**Written Comments Received During the Public Scoping Period**

**for the  
Valley-Ivyglen and Alberhill Projects**

**Comments from the Applicant: Southern California Edison**

**Re: Southern California Edison's Comments to the Draft Environmental Impact Report for the Alberhill System Project and Valley-Ivyglen Subtransmission Line Project**

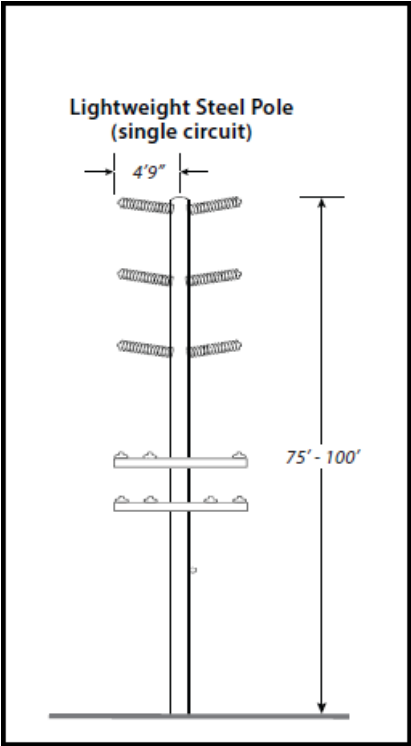
Valley-Ivyglen	2.1.1	2-1	<p>Line 31 under heading Valley-Ivyglen Project Overview states:</p> <p>“The applicant estimates that construction of the proposed Valley–Ivyglen Project would take approximately 27 months. It is anticipated that the proposed Valley–Ivyglen Project would be operational by the summer or fall 2018.”</p>	<p>Per SCE project description edits submitted in September 2015, SCE suggests the following edits:</p> <p>“The applicant estimates that construction of the proposed Valley–Ivyglen Project would take approximately <del>27</del><sup>28</sup> months. It is anticipated that the proposed Valley–Ivyglen Project would be operational by <del>the summer or fall 2018</del><sup>Q4 2019</sup>.”</p>
Alberhill/Valley-Ivyglen	2.1.1	2-2	Figure 2-1	<p>Placing the red dashed line adjacent to the blue line gives the impression that there are two new 115-kV subtransmission pole lines when in fact there is one existing pole line (not shown) and one double-circuit proposed pole line (red dash and blue line). SCE suggests the following edits:</p> <p>Please move the blue line (for Valley-Ivyglen) north of the green line (existing Serrano-Valley 500 kV) between Valley Substation and Highway 74. Also, please move the dash red line (Alberhill</p>

Project	Section	Page	DEIR Language	SCE Recommended Language
				115 kV) on top of the blue line (Valley-Ivyglen) from Third and Collier up to Alberhill Substation.
Alberhill	2.1.1	2-11	Figure 2.2i	Project Map does not differentiate between SCE’s proposed and existing access roads. Please differentiate between proposed and existing access roads.
Alberhill	2.1.2	2-12	Line 12-14 – Under heading Alberhill Project Overview states:  "Construction of approximately 11.75 miles of new double-circuit 115kV subtransmission lines and removal of 11 miles of existing single-circuit 115-kV subtransmission lines primarily in the existing ROW;"	SCE recommends following edits:  “ <del>Double-circuit</del> Construction of approximately 11.75 miles of <del>existing single-circuit</del> <u>new double circuit</u> 115-kV subtransmission lines <u>with structure replacement and removal of 11 miles of existing single circuit 115 kV subtransmission lines</u> primarily in the existing ROW;”

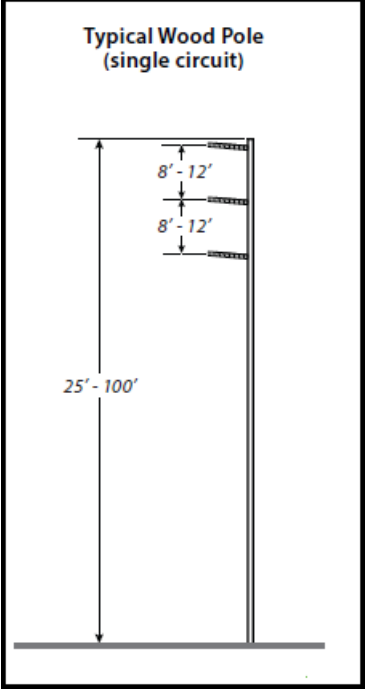
Project	Section	Page	DEIR Language	SCE Recommended Language
Alberhill/ Valley- Ivyglen	2.3.1	2-18	<p>Figure 2-4 states:</p> <p>“Lightweight Steel Pole (single circuit)”</p> 	<p>SCE suggests the following edits:</p> <p>“Lightweight Steel Pole (<del>single</del><u>double</u> circuit)”</p>
Alberhill/ Valley- Ivyglen	2.3.1	2-18	<p>Figure 2-4 states:</p> <p>“Typical wood pole (single circuit) 25' - 100' “</p>	<p>SCE suggests the following edits:</p> <p>“Typical wood pole (single circuit) <del>25</del><u>75</u>' – 100’</p> <p>Please add the following dimensions to the Span Guy in Figure 2-4:</p>

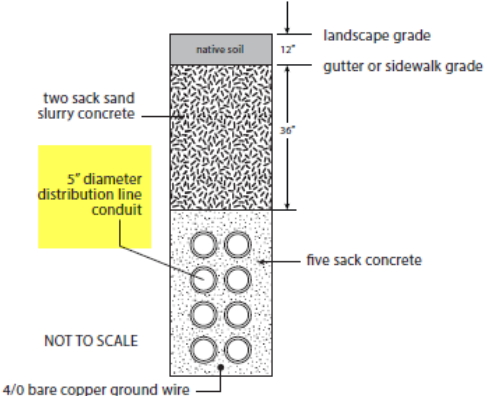
Project	Section	Page	DEIR Language	SCE Recommended Language
			 <p style="text-align: center;">Typical Wood Pole (single circuit)</p> <p style="text-align: center;">8' - 12'</p> <p style="text-align: center;">8' - 12'</p> <p style="text-align: center;">25' - 100'</p>	Guy stub poles are typically 35' – 50'
Alberhill/ Valley- Ivyglen	2.3.1.1	2-18	<p>Figure 2-4, Subtransmission Structures and Underground Conduit - Distribution Underground Duct Bank Configuration figure states:</p> <p>“Typical Underground Duct Bank Configuration for Underground Distribution Line Installations”</p> <p>5” diameter distribution line conduit</p>	<p>Please relabel figure to read:</p> <p>“Typical <del>Underground</del> Duct Bank Configuration for Underground <del>Distribution</del> <u>Sub-transmission</u> Line Installations”</p> <p>5” diameter <del>distribution line</del> conduit</p>

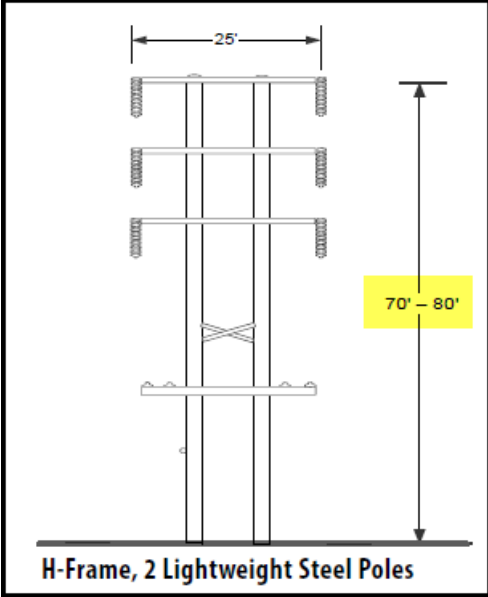
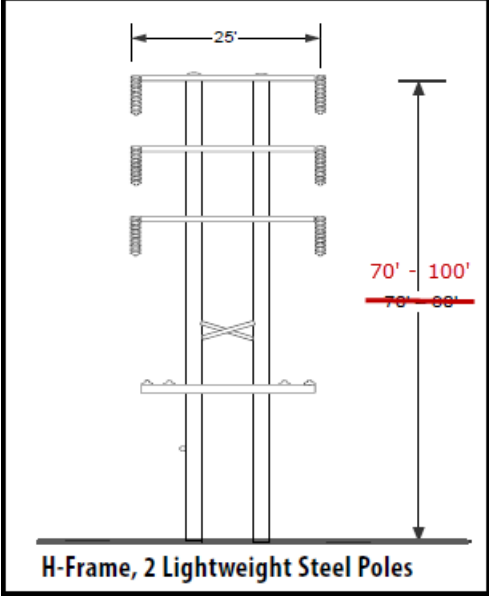
New fiber optic telecommunication line installed on two 115-kV line taps into the proposed Alberhill Substation	n/a	• 2,000 feet • 650 feet underground	New fiber optic telecommunication line installed on two 115-kV line taps into the proposed Alberhill Substation	n/a	• 2,000 feet • 650 feet underground
			New fiber optic telecommunication line installed on 115-kV Segments ASP1, ASP1.5, ASP5, ASP6, and ASP7	n/a	• 8.66 miles • 1.11 miles underground

Project	Section	Page	DEIR Language			SCE Recommended Language		
			New telecommunications equipment installed inside existing substations (e.g., microwave radios)	n/a	n/a	New fiber optic telecommunication line installed on 115-kV Segments ASP1, ASP 1.5, ASP5, ASP6, and ASP7	n/a	<ul style="list-style-type: none"> <li>• 8.66 miles</li> <li>• 1.11 miles underground</li> </ul>
						New telecommunications equipment installed inside existing substations (e.g., microwave radios)	n/a	n/a
Alberhill	2.3.2	2-29	Table 2-2 : The number of wood pole removals for ASP8 are not provided in the Quantity column			Please add “ <u>(3 wood poles removed)</u> ” to the Quantity column of Segment ASP8.		
Alberhill	2.3.2.1	2-39	<p>Line 15 under heading Entrance, Love Lane, Gates, Driveways, Parking and Perimeter Wall states:</p> <p>“The wall would be constructed to safety standards and may need to comply with the current version of NERC/CIP requirements for major electrical facilities. It would be designed to be consistent with the surrounding community’s construction standards. A band of at least three strands of barbed wire would be affixed near the top of the perimeter wall inside the proposed Alberhill Substation. The barbed wire would not be visible from outside the substation. Landscaping and irrigation would be installed after the proposed Alberhill Substation wall is constructed.”</p>			<p>Per Data Request response G4, SCE suggests the following edits:</p> <p>“The wall would be constructed to safety standards and may need to comply with the current version of NERC/CIP requirements for major electrical facilities. It would be designed to be consistent with the surrounding community’s construction standards. A band of at least three strands of barbed wire <u>and/or a top guard (e.g., barbed wire or spiked strips)</u> would be affixed to <u>near the top of the perimeter wall of inside</u> the proposed Alberhill Substation. <del>The barbed wire would not be visible from outside the substation.</del> Landscaping and irrigation would be installed after the proposed Alberhill Substation wall is constructed.”</p>
